<div style="text-align: center;">  <p>DELPHI PACKARD ELECTRIC SYSTEMS WARREN, OH</p> </div>							
						DATE	
DR ALLEN ZHANG						25M07	
APV01 ALLEN ZHANG						25M07	
APV02 OLIVER YU						25M07	
APV03 OLIVER YU						25M07	
APV04							
APV05							
SUBSTANCES OF CONCERN AND REC/CLED CONTENT PER DELPHI 10949001							
MATERIAL POLYESTER BLEND BLACK							
DRAWING NAME							
DRAWING NUMBER							
<div style="text-align: center;">  </div>							
SIZE A0	SCALE 2:1	FRAME NO 1 OF 1	SHEET NO 1 OF 1	STS R	REV 02	NEW NA	AA

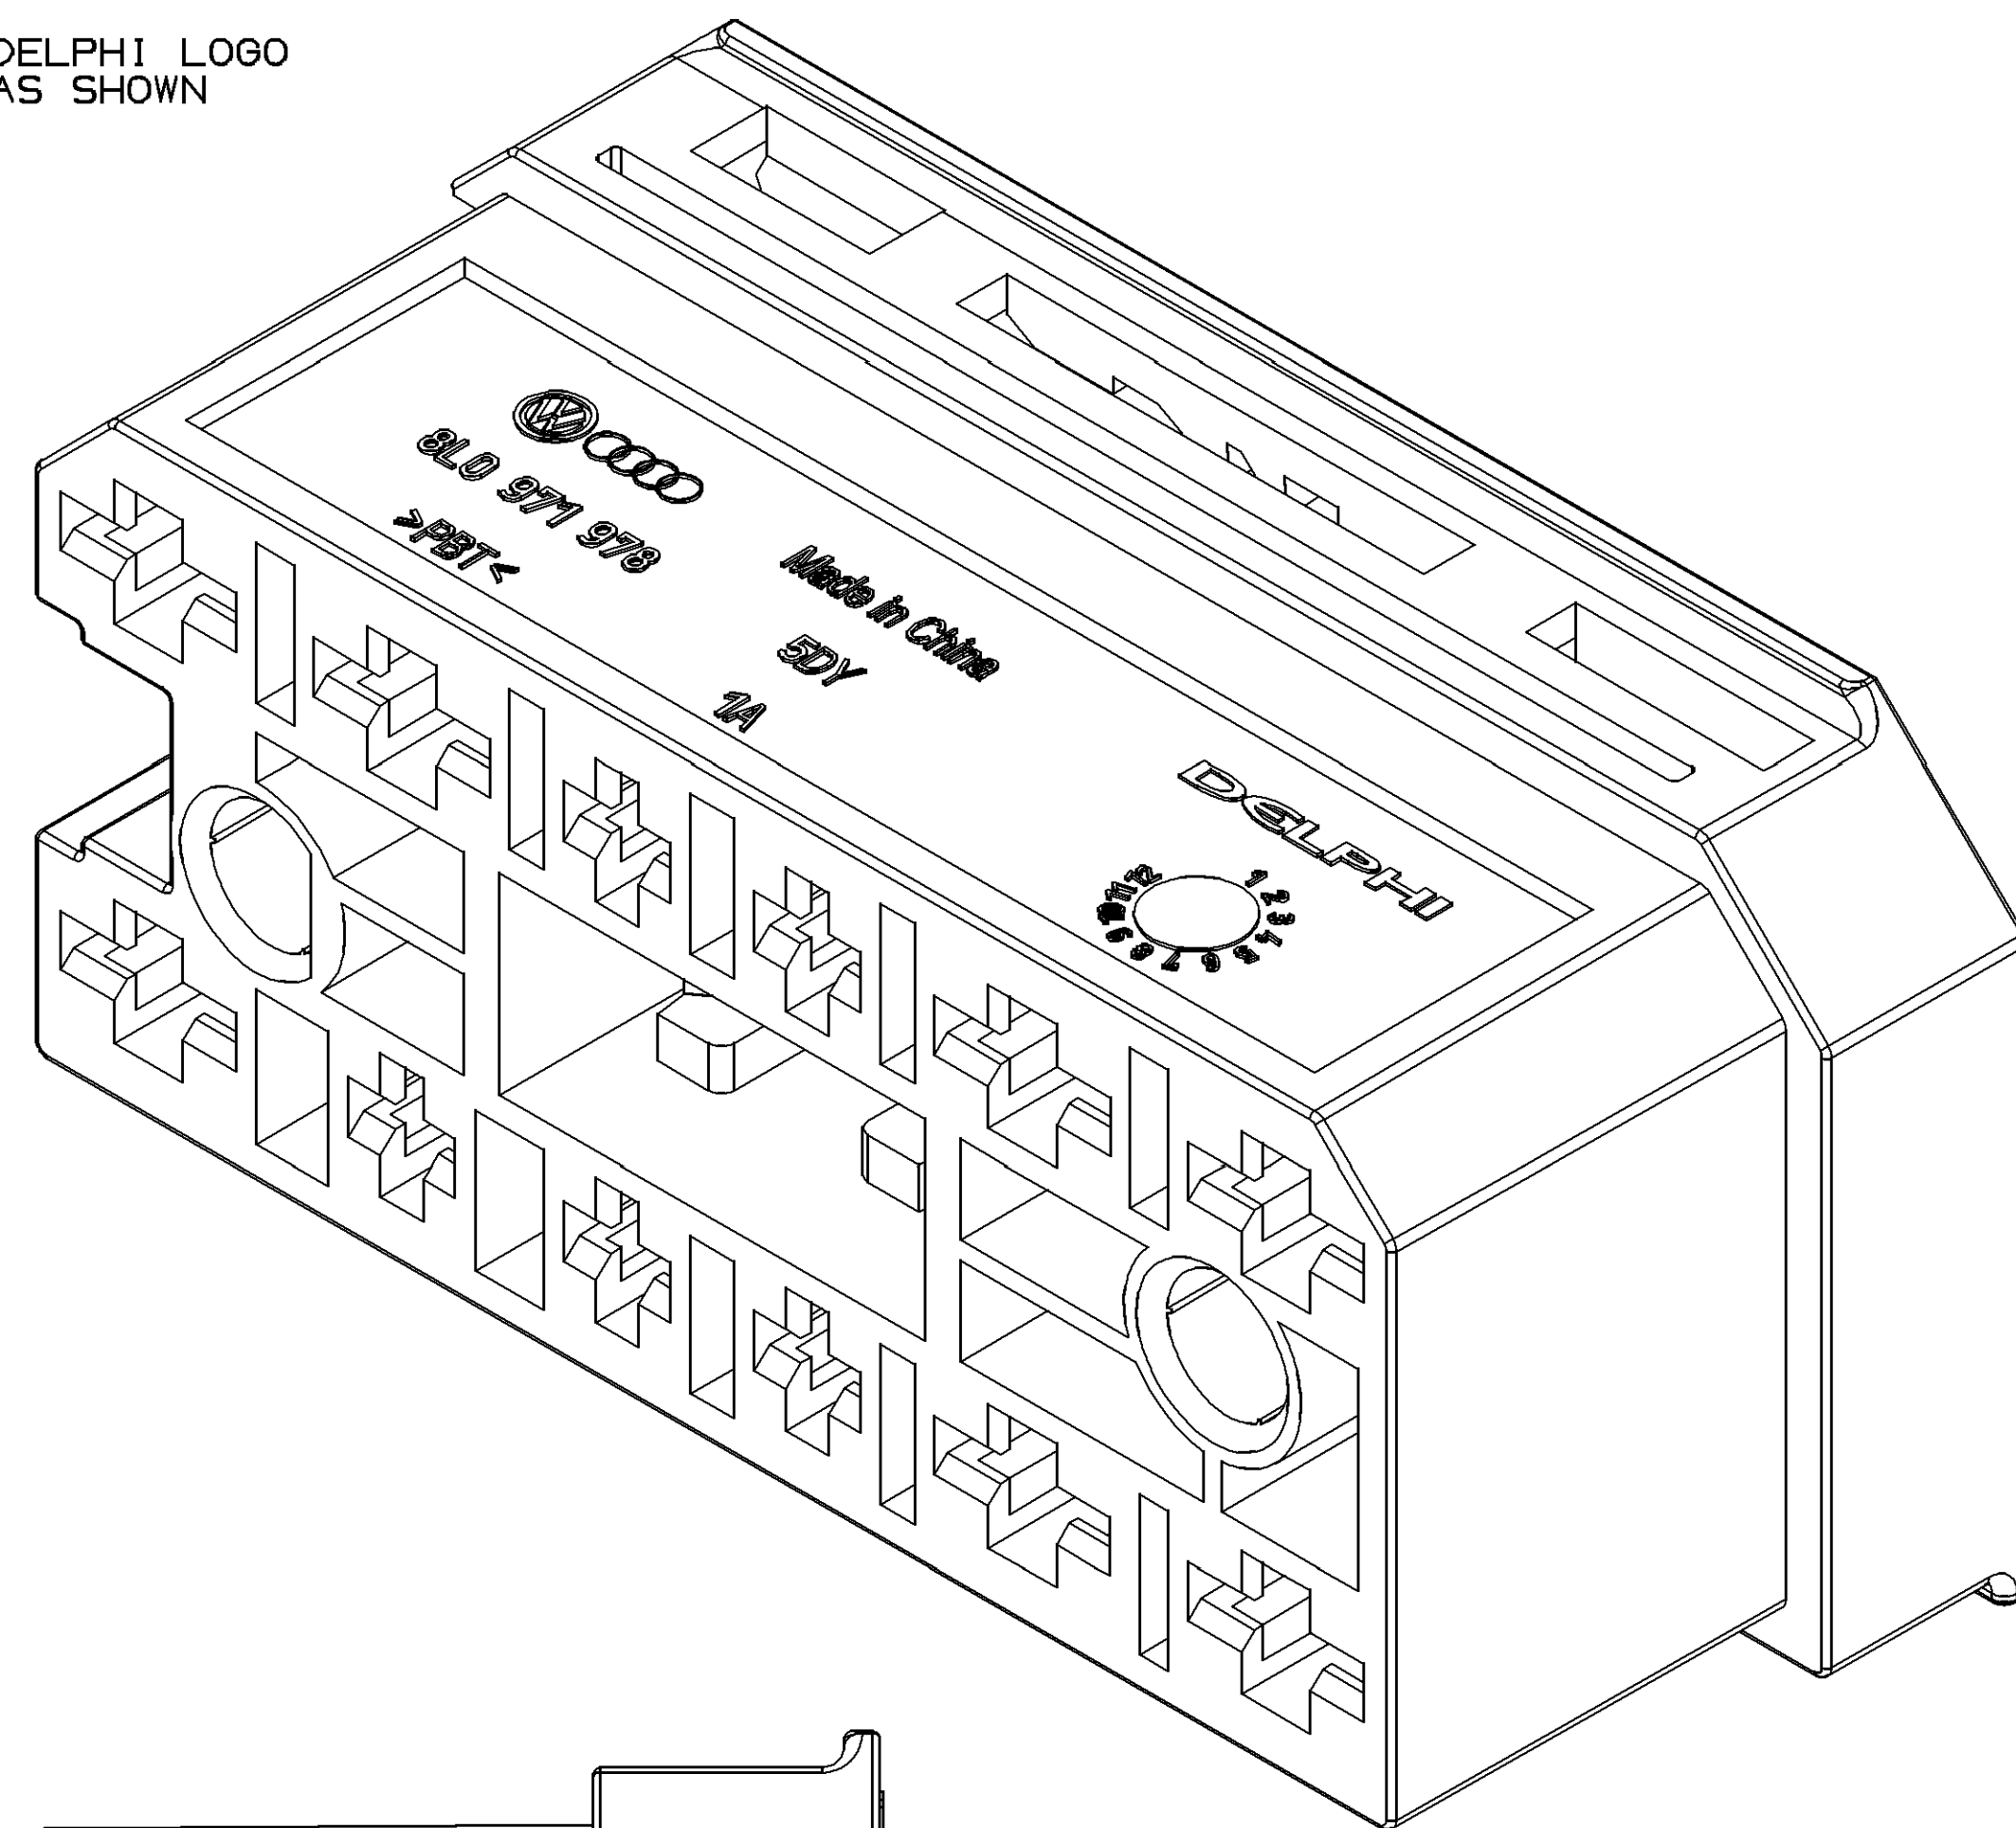
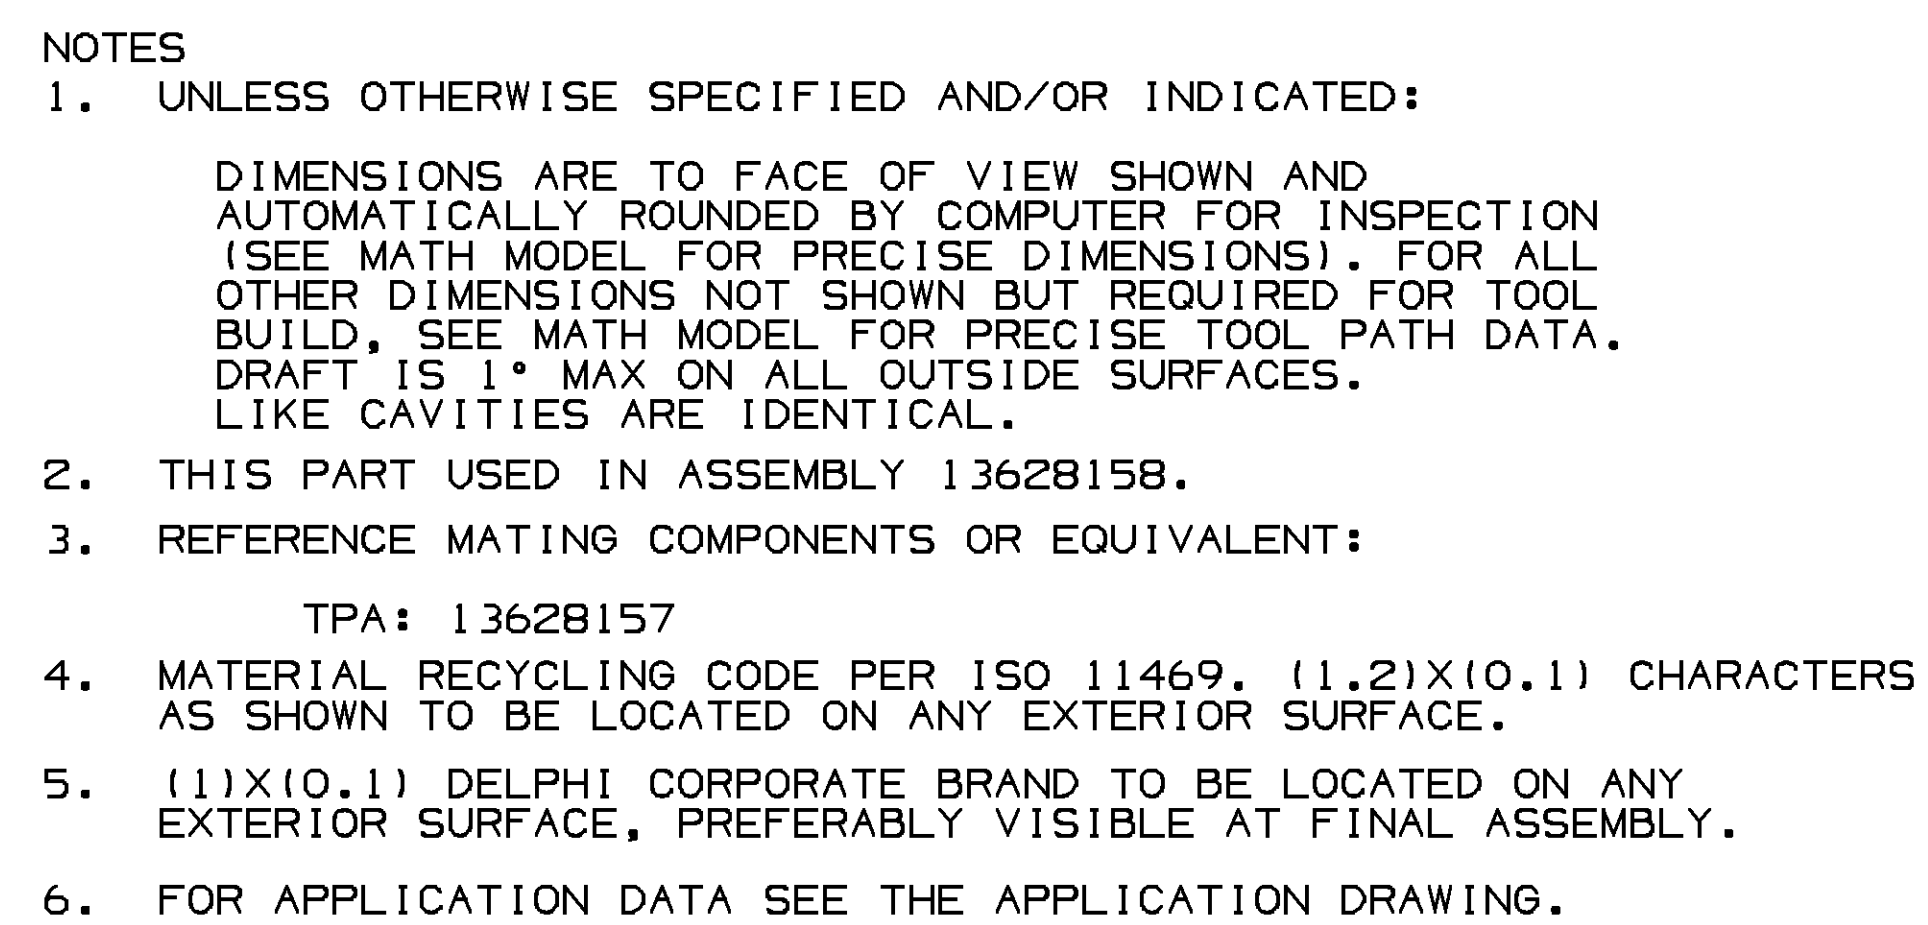
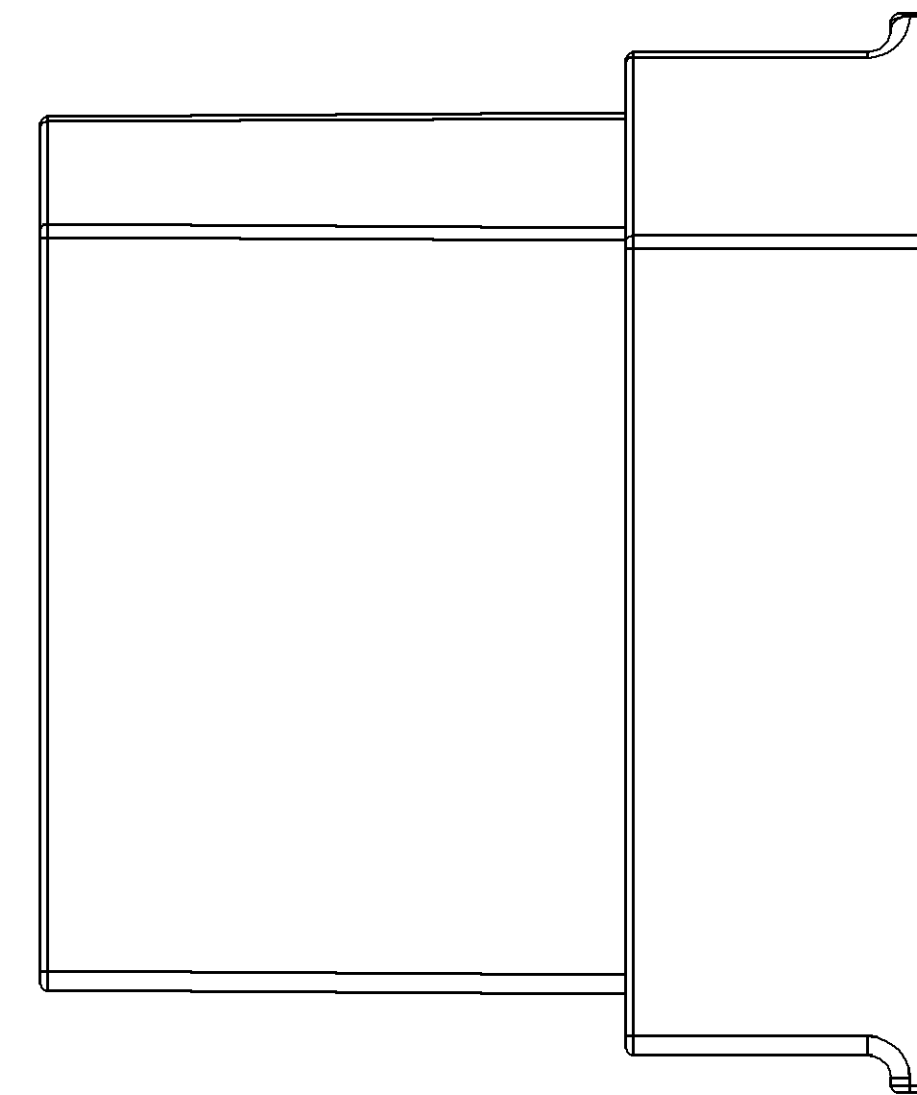
MISSING SYMBOLS	DWG STATUS					ZONE	REVISION HISTORY	AUTH	DR	APD/APD I 2	
	DATE	STG	REV	N/F	CHG					1	2
NO MISSING SYMBOL NUMBER	25MY07	R	01	-	-	RELEASED		401421	AZ	OY	OY
	29OC08	R	02	-	-	REVISED THE VW LOGO ADDED DIM. #5, #15 REVISED DIM. #1 WAS 23.15+/-0.1 #4 WAS 23.5+/-0.1 #7 WAS 1.7+0.1/-0 #12 WAS 28.55+/-0.1 #13 WAS 57+/-0.3 #16 WAS 53.6+/-0.3		406635	JBN	JWB	EZ
	20JL09	R	02	AA	-	CORRECTED DRAWING		408336	K.W	JWB	EZ
